COMMONWEALTH OF KENTUCKY  
BEFORE THE PUBLIC SERVICE COMMISSION

ELECTRONIC APPLICATION OF KENTUCKY	)	
UTILITIES COMPANY FOR AUTHORIZATION	)	CASE NO.
OF CHANGES IN SERVICE TERRITORY	)	2020-00319
WITH CLARK ENERGY COOPERATIVE, INC.	)

COMMISSION STAFF'S FIRST REQUEST FOR INFORMATION  
TO KENTUCKY UTILITIES COMPANY

**Coordinates for:**

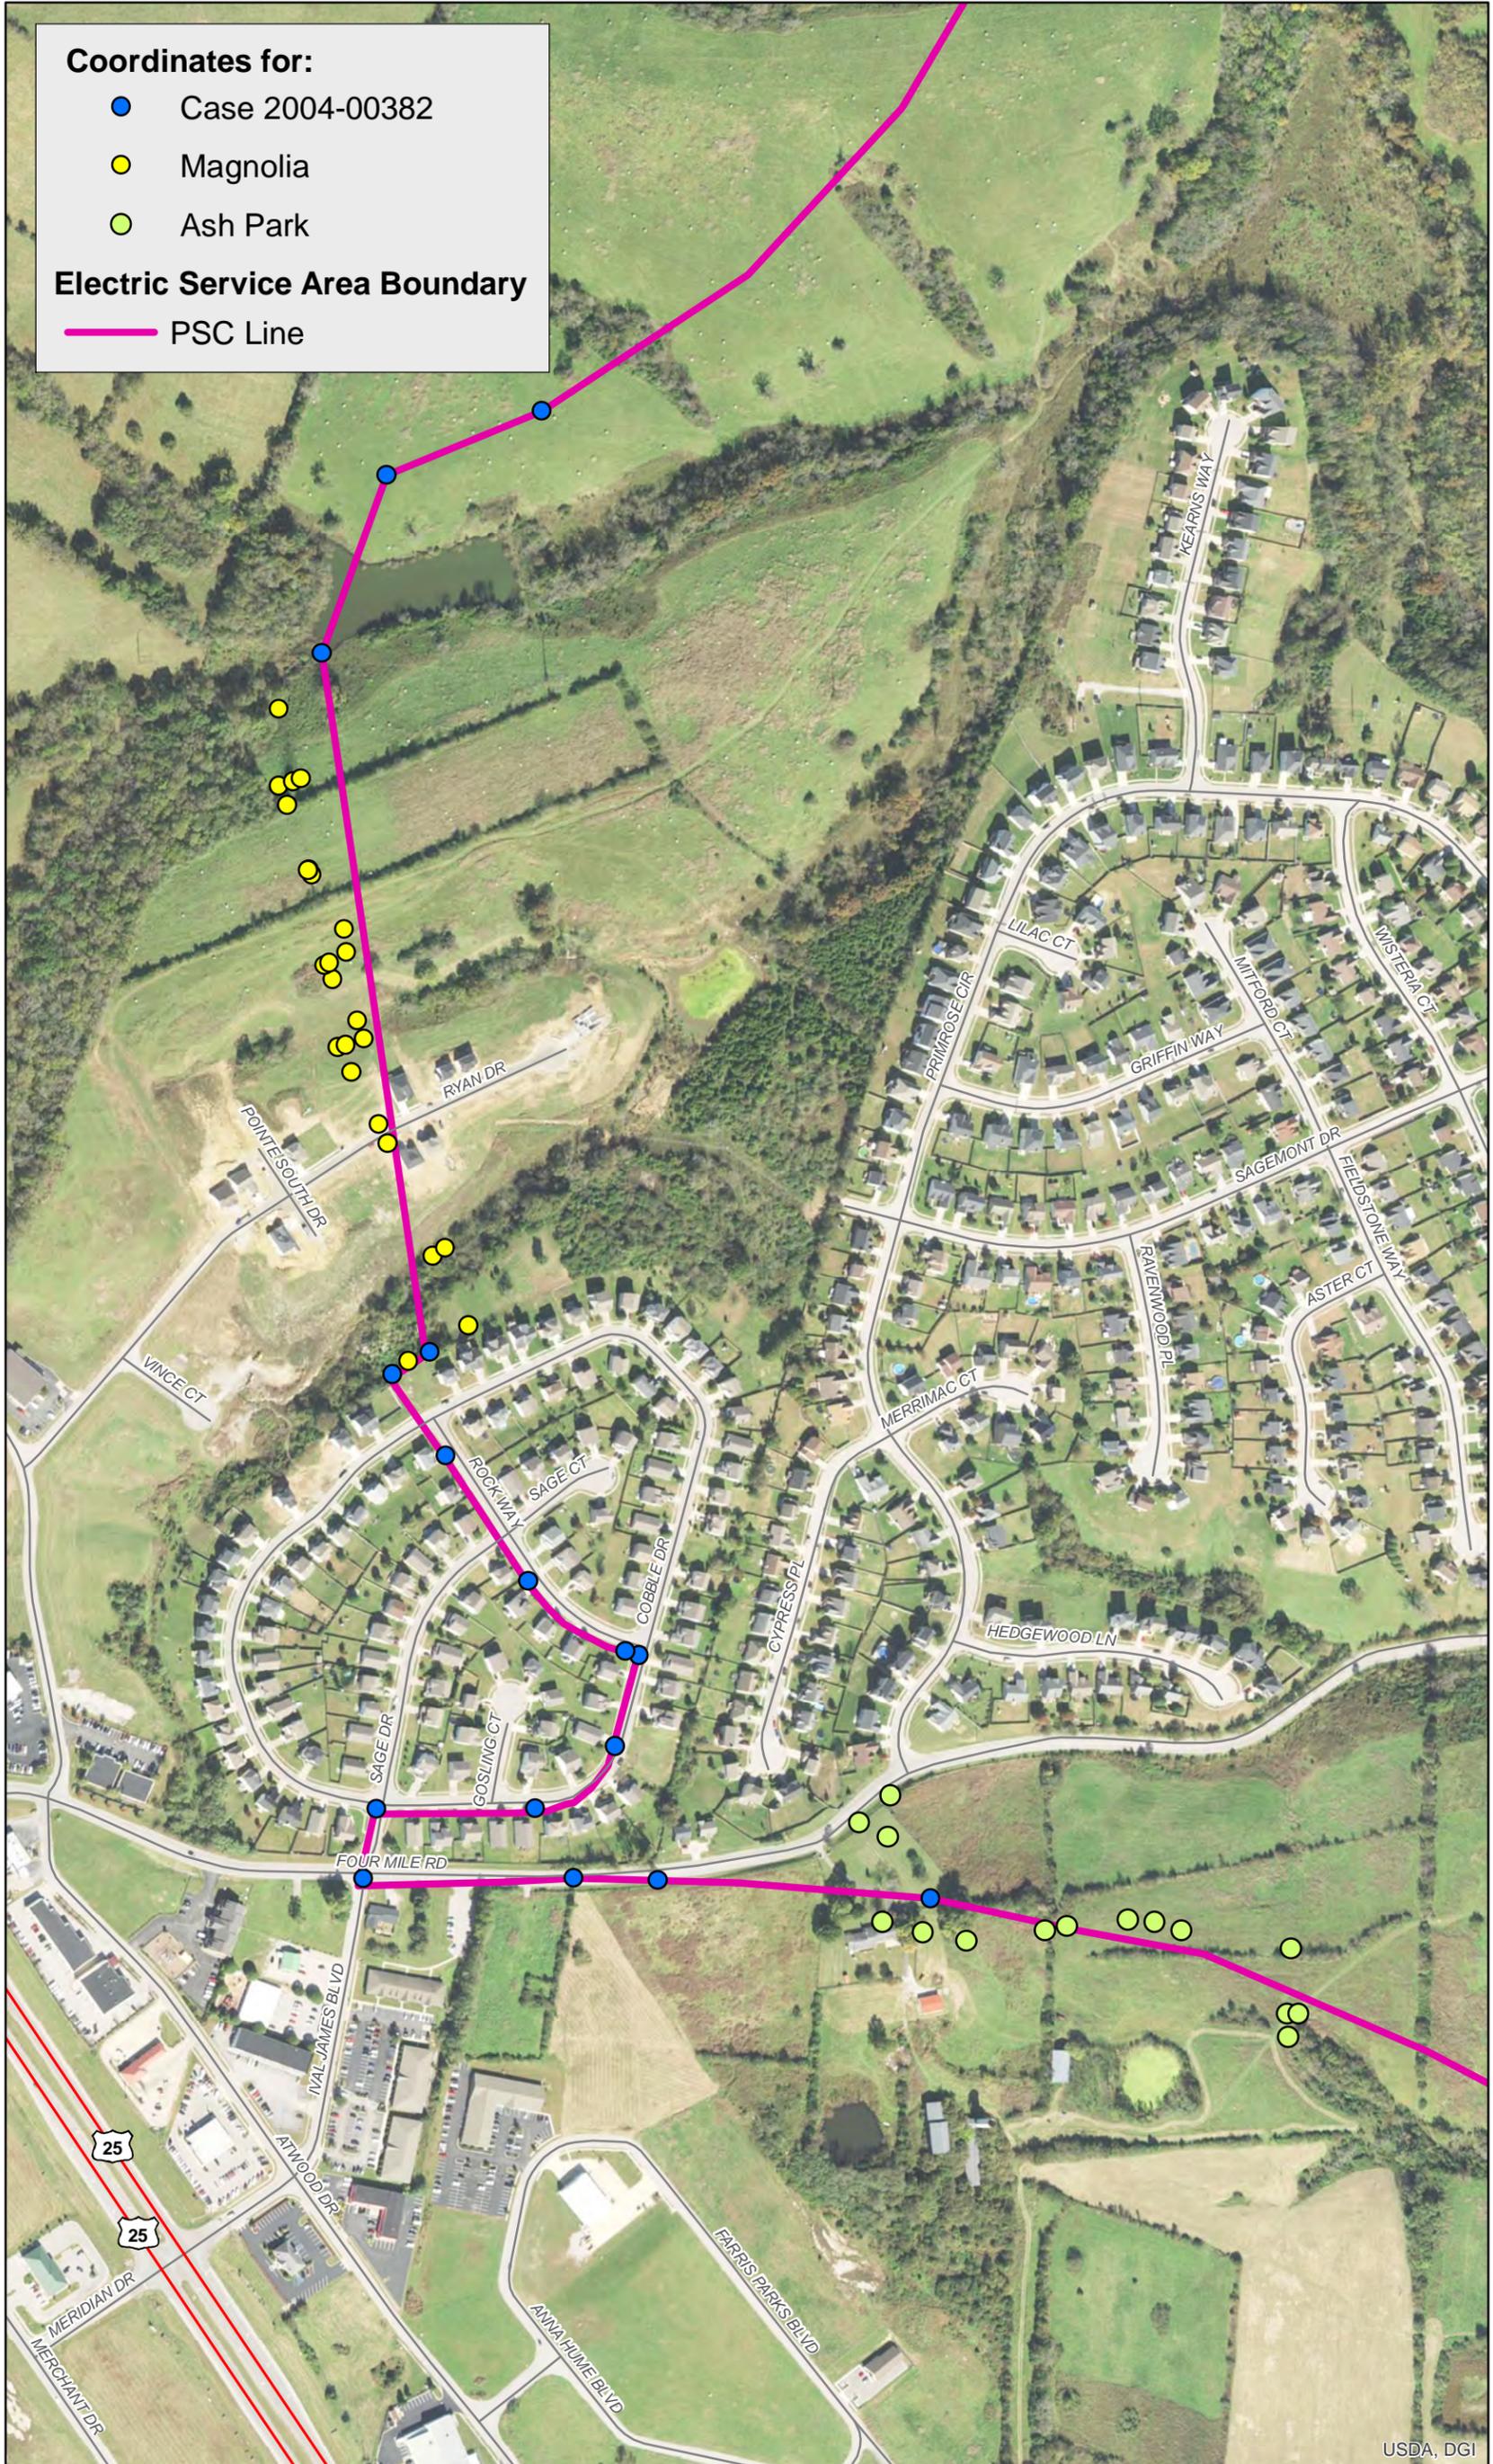
The northings and eastings for the proposed service boundary on that map agree with the ones in the written agreement submitted as part of Case 2004-00382. A copy of the map from Case No. 2004-00382 is attached as Appendix A with this request for information. There are some northings and eastings on the map that define the existing service area boundary. This is a more exact definition of the existing service area boundary than one on the 1:24,000 Richmond North USGS Topo Map quadrant map signed in 1995; therefore, this is the definition of the existing electric service area boundary that should be used for this proceeding. As illustrated in the attached map in Appendix B, Magnolia Pointe is located along the northern part of the existing line and Ash Park begins along the southern part of the line defined by Case No. 2004-00382. Confirm that the existing electric service area boundary is the one defined in map filed in Case No. 2004-00382.

2. Provide a new map and new coordinates for Magnolia Pointe that incorporate the existing service area boundary from Case No. 2004-00382 that is signed and dated by both companies.

3. Provide a new map and new coordinates for Ash Park that incorporate the existing service area boundary from Case No. 2004-00382 that is signed and dated by both companies.

4. If the description of the boundaries for Magnolia Pointe or Ash Park change in terms of the lots involved, revise the description.
